Re: **FIVE-YEAR PERMIT RENEWAL, DES-BEE-DOVE MINE,
ACT/015/017, FOLDER #2, EMERY COUNTY, UTAH
ABATEMENT TO CESSATION ORDER NO. C90-20-2-1**

**PAP
ORGANIZATION LISTING
FOR PERMIT RENEWAL RESPONSE
SEPTEMBER 27, 1990**

Utah Power and Light Company
Emery County, Utah
June 25, 1990

RE: Five-Year Renewal, Utah Power and Light Company, Des-Bee-Dove Mine,
ACT/015/017, Folder #2, Emery County, Utah

EARTH WORK CALCULATION - DBD HAULER 40 RECLAMATION

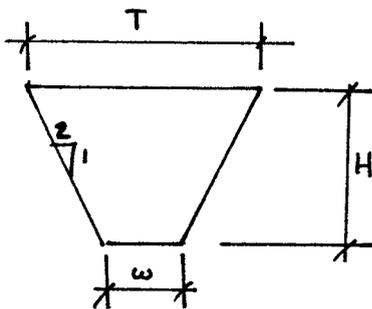
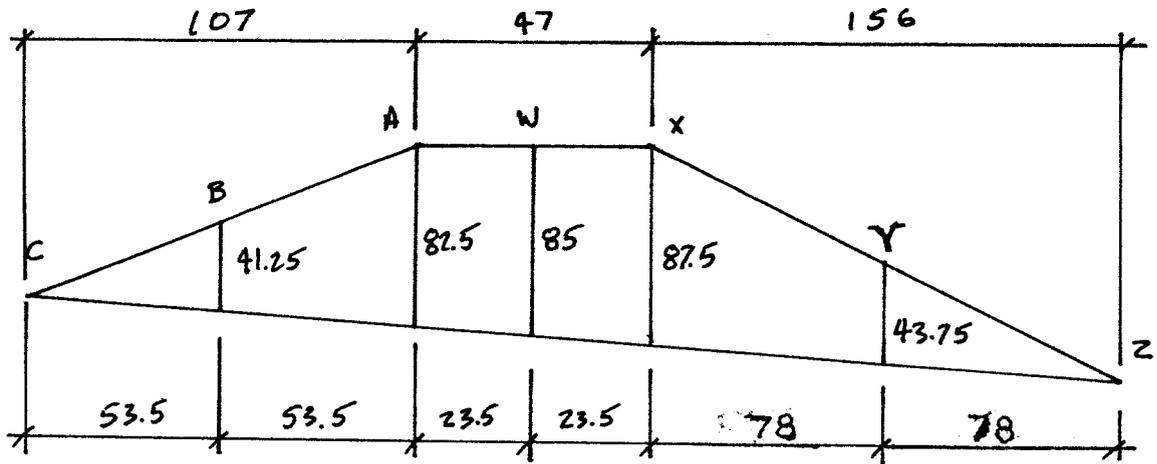
A review of the road reclamation drawings and calculations shows that there may be some problems with the balance of earthwork volumes. The method used to calculate the volume of material to be excavated at the culverts has resulted in an error of approximately one-third. The calculated volumes are one-third larger than the actual volumes which will result in less material actually available for burying road surface materials in the fill slopes and achieving approximate original contour. This needs to be re-evaluated and the reclamation plan revised to provide for the necessary 4 foot of cover and available material to return the disturbed area to approximate original contour.

6. The Des-Bee-Dove haul road reclamation plan includes calculations of earthwork volumes required to remove the existing culverts and establish drainage channels. The quantities to be moved were used to determine the cost at the reclamation effort as well as to determine if sufficient material is available to accomplish the goals of burying the road surface material and returning the area to the approximate original contours. The method used to calculate the earthwork volumes was the average end area method, which is the most commonly used method for road design. This method does over-estimate the quantity of material in some cases, especially where the end area is zero at one end of the section.

In Section F, page 4-124, Des-Bee-Dove to Cottonwood/Wilberg haul road, subsection 1, calculations were made of the amount of material to be excavated to remove the culverts which are not to be replaced by drainage channels. This quantity was used to determine the cost of this task. This material was not included in the plan for covering road surface material or for regrading the slopes to return the area to the approximate original contour. Because the volume was over-estimated and therefore the calculated cost was higher than actual, the reclamation bond value is sufficient.

In subsection 2 of Section F, page 4-125, the volume of material to be removed in order to establish the new drainage channels was calculated. Here again, because the method used over-calculated the volume, the cost associated with this task is estimated at a rate above the actual and the bond amount is still sufficient. The other concern is if there is enough soil material to cover the road surface material and to return the area to the approximate original contour.

For reclamation, the road surface materials consisting of 10,284 cubic yards of asphalt and 16,102 cubic yards of base coarse are to be placed on the existing road grade between station 123+50 to station 141+00. The previous plan was to use 107,515 cubic yards from the channel excavation at station 146+00 to cover this road surface material. Upon recalculation the correct volume from the excavation at station 146+00 is 83,918 yards, the remaining 23,597 cubic yards of cover material will come from the excavation at station 156+50. The correct volume of material from station 156+50 excavation is 29,571 cubic yards. Therefore, there is sufficient material in the two excavations at station 146+00 and 156+50 to cover the road surface materials.

The certified road design summary sheet (plate 5-1, sheet 5 of 38) itemizes the quantity of excess excavation and borrow required to construct the road. The final amounts are 54,529 cubic yards of borrow and zero excavation, along with the 41,746 tons of base coarse and 25,364 tons of asphaltic concrete. Because of the net gain of material to construct the road the fact that none of the natural soil was disposed of at the site, it is obvious that sufficient soil material exists on the road grade to return the area to the approximate original contour.
